FORD A4LD FRONT PLANETARY GEARSET CHANGES

CHANGE:

REASON: Greater torque carrying capacity because of increased horsepower demands.

Figure 1

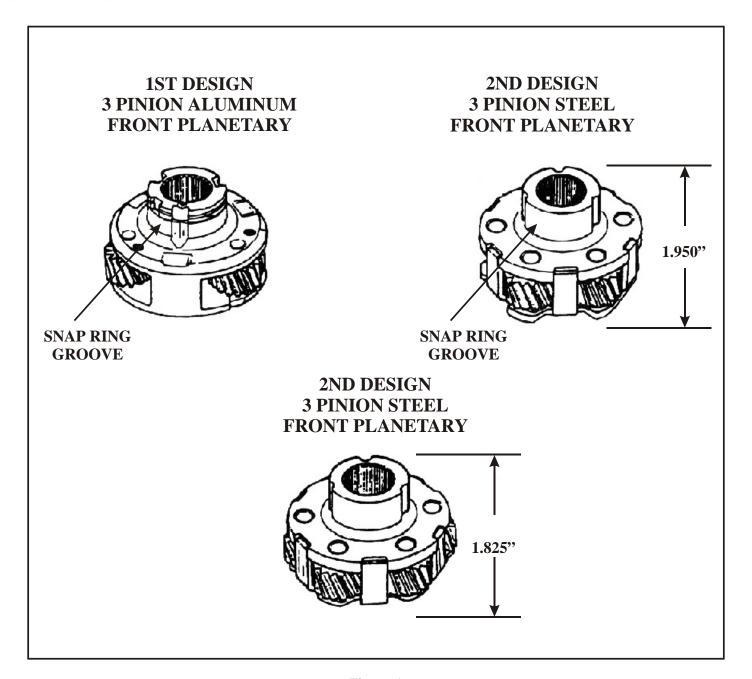
Sometime in model year 1987, the 1st design 3 pinion aluminum front planetary carrier was replaced with a revised 4 pinion steel front planetary carrier (See Figures 1 and 3). In model year 1990, on 4.0L engine models only, the steel front planetary carrier was once again revised to a 6 pinion steel carrier (See Figures 1 and 3). These changes have affected many of the related parts and created confusion for many rebuilders.

- (1) FRONT PLANETARY CARRIER The 1 st design 3 pinion aluminum carrier was eliminated and replaced with a revised 4pinion steel carrier. The snap ring groove and the snap ring that previously retained the carrier into the ring gear were eliminated (See Figure 1). In 1990 the steel carrier was once again upgraded with a 6pinion steel carrier, for 4.0L engine models only. The 6 pinion steel carrier was also shortened in overall height, by approximately .125", to accommodate a new design number 6 (3 piece) thrust bearing (See Figures 1 & 3). NOTE: The 1st Design 3 pinion aluminum and 2nd Design 4 pinion steel front carriers are no longer serviced by Ford Motor Co. They are now upgraded to the latest 3rd Design 6 pinion steel front planetary system, which comes as a service package and includes all necessary hubs and washers to make it compatable.

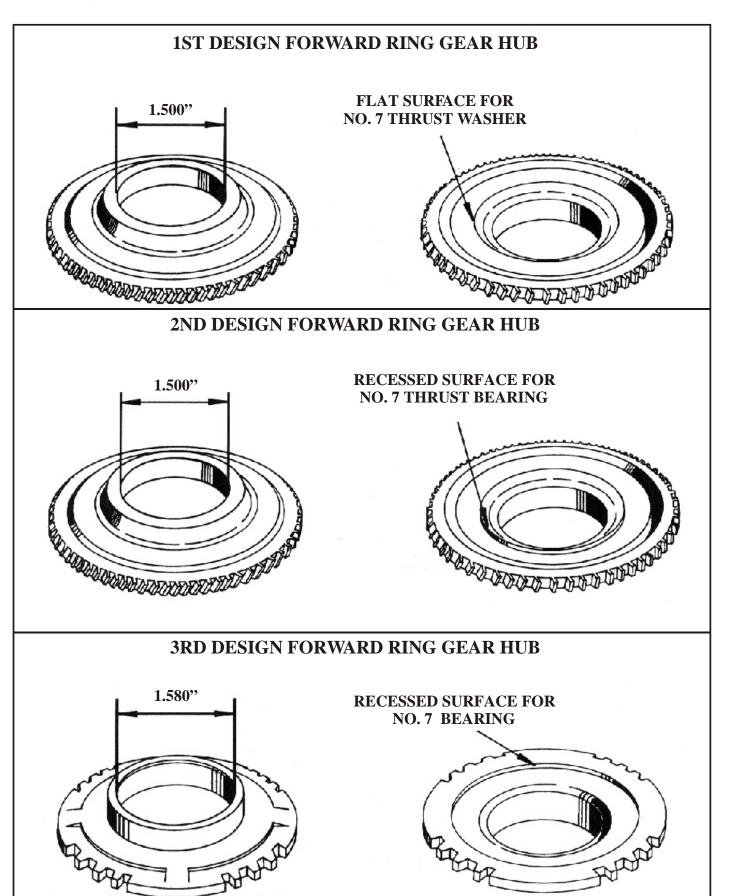
- (2) FORWARD RING GEAR HUB The 1st Design forward ring gear hub uses a number 7 thrust washer as shown in Figure 3. On the 2nd Design ring gear hub, a recess was machined to accommodate an added number 7 thrust bearing, that replaced the number 7 thrust washer. Refer to Figures 2 and 3. Both 1 st and 2nd design ring gear hubs inside diameter measure 1.500", as shown in Figure 2.

On the 3rd Design ring gear hub the inside diameter was machined approximately .080" larger to accommodate a new design number 6 "Top Hat" thrust washer (See Figure 3). The inside diameter on the 3rd Design ring gear hub measures 1.580", as shown in Figure 2.

- (3) **NUMBER 6 THRUST WASHER** Was changed from a 3 tab thrust washer to a "Top Hat" design thrust washer in 1987 (See Figure 3). This change is what required the larger inside diameter on the ring gear hub. Beginning in 1990, on 4.OL engine models, the number 6 "Top Hat" thrust washer was replaced with a new number 6 (3 Piece) thrust bearing, as shown in Figure 3. Notice also the added washer (7D090), that must be used with the 3 piece bearing design (See Figure 3). This is what required the carrier to be machined shorter. The 3 piece thrust bearing has now been changed to a normal "Torrington" (Snap Together) type bearing and replaces the 3 piece design without any other changes.

- (4) **NUMBER 7 THRUST WASHER** Sometime in 1986, the number 7 thrust washer was eliminated, and replaced with a number 7 thrust bearing as shown in Figure 3. This change required the machined recess in the ring gear hub, to make room for the thrust bearing, as shown in Figure 2. The number 7 thrust bearing is still used through current production (See Figure 3).

- (1) The 1st Design 3 pinion aluminum front planetary carrier system, as shown in Figure 3, is recommended for nothing larger than 2.3L engine models. The 1st Design 3 pinion aluminum front planetary carrier is no longer serviced by Ford Motor Co. It now upgrades to the latest 3rd Design 6 pinion steel front planetary carrier system, which comes as a service package and includes all necessary hubs and washers to make it compatible, and is available under OEM part number F0TZ-7A398-E.

- (2) The 2nd Design 4 pinion steel front planetary carrier system, as shown in Figure 3, with the 1.580" inside diameter ring gear hub, the number 7 thrust bearing, the number 6 "Top Hat" thrust washer WILL retro-fit back on all models, except 4.0L engine models, but all parts listed above must be used as an assembly (See Figure 3). The 2nd Design 4 pinion steel front planetary carrier is no longer serviced by Ford Motor Co. It now upgrades to the latest 3rd Design 6 pinion steel front planetary carrier system, which comes as a service package and includes all necessary hubs and washers to make it compatible, and is available under OEM part number F0TZ-7A398-E.

- (3) The 3rd Design 6pinion steel, 4.0L engine front planetary system, as shown in Figure 3, with the 1.580" inside diameter ring gear hub, the number 7 thrust bearing, number 6 (3 Piece) thrust bearing, and bushing (7D090) WILL retro-fit back on all previous models, but the parts listed above are mandatory on 4.0L models (See Figure 3).

Figure 4
AUTOMATIC TRANSMISSION SERVICE GROUP

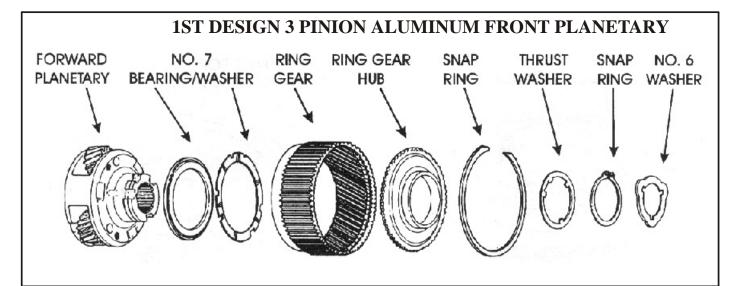
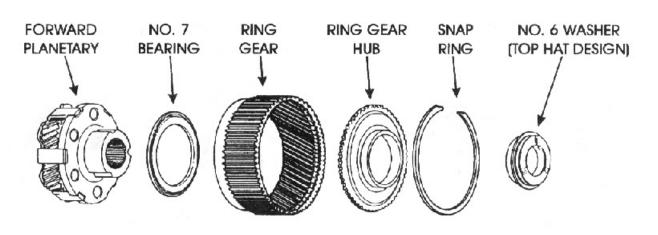
2ND DESIGN 3 PINION STEEL FRONT PLANETARY
